California
**Department of
Conservation**
CalGEM

CES Class VI Permit Application Review

October 20, 2020

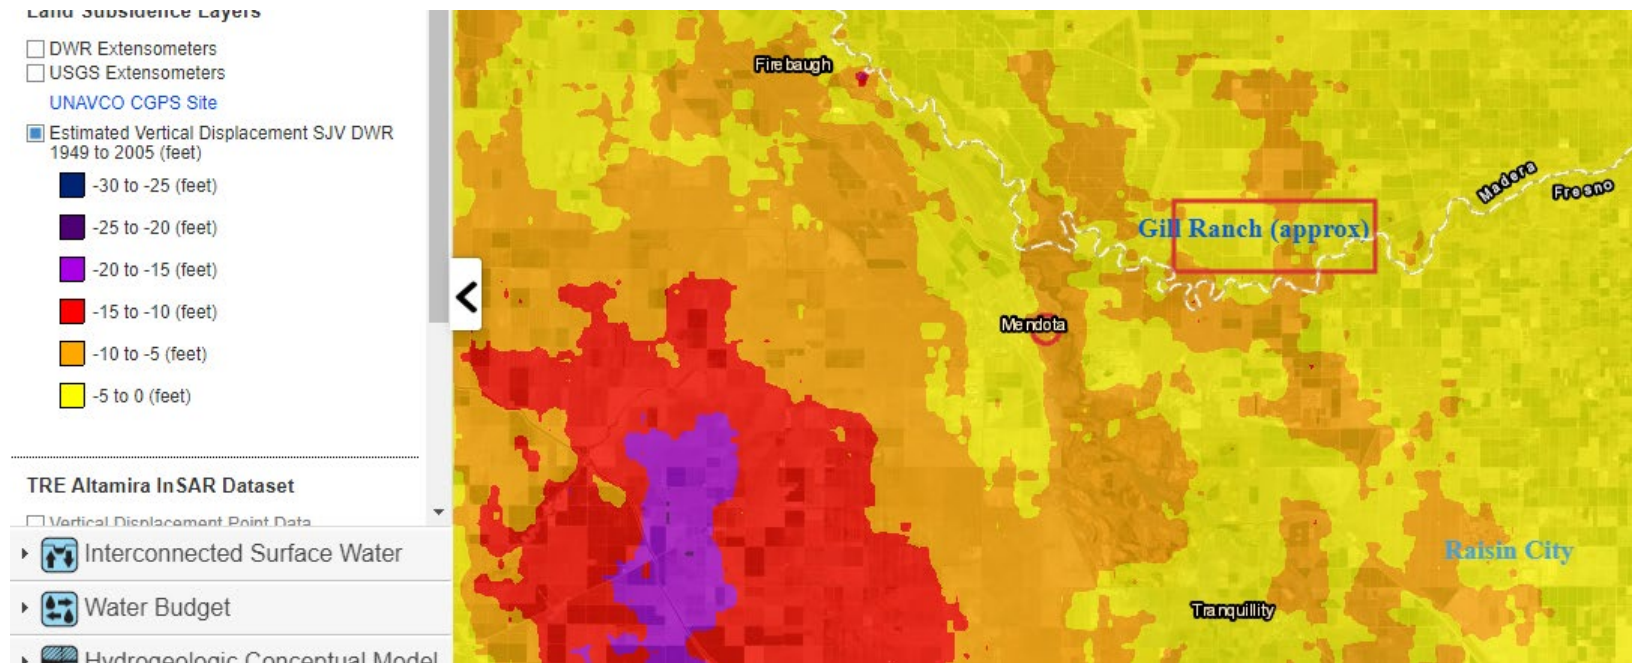
- The minimum recording frequency of 5 min in Table 2 of Attachment C seems long. A 1 minute recording frequency is suggested.

Nearby Gill Ranch Field Rules

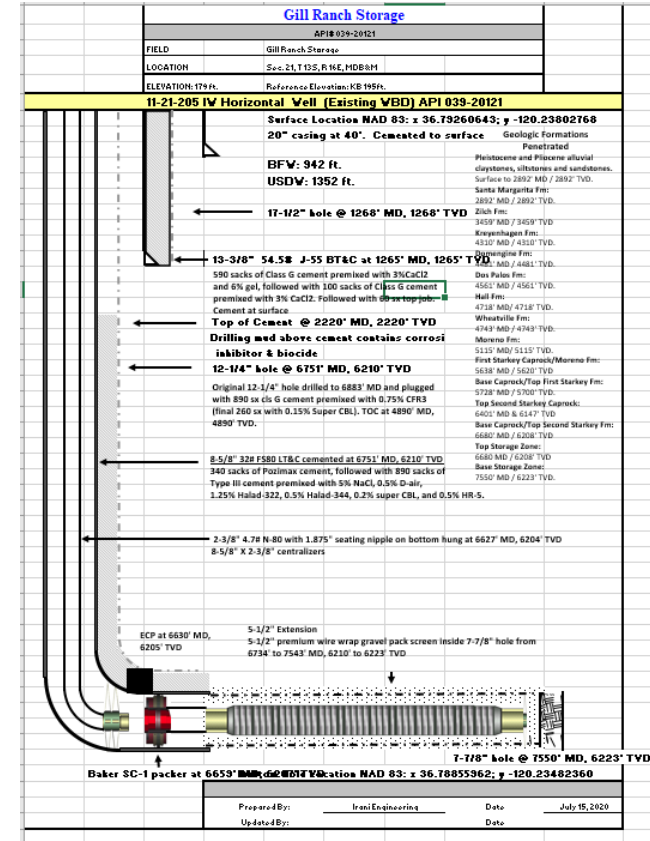
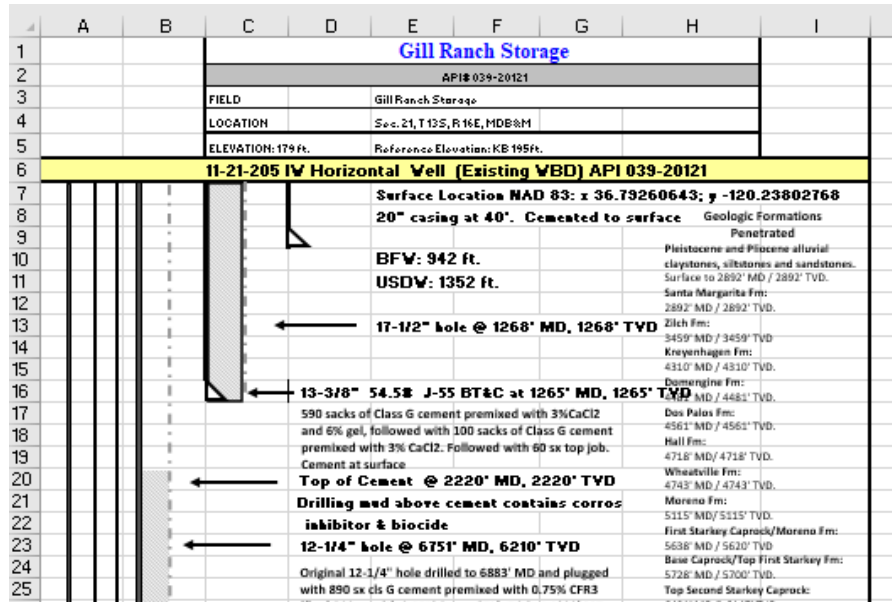
In the Gill Ranch Gas field there is significant land subsidence caused from water production for agricultural uses. The well casing is subject to compression and failure from the water producing depth to the surface. The well casing should be unlanded to relieve the stress every 5 years.
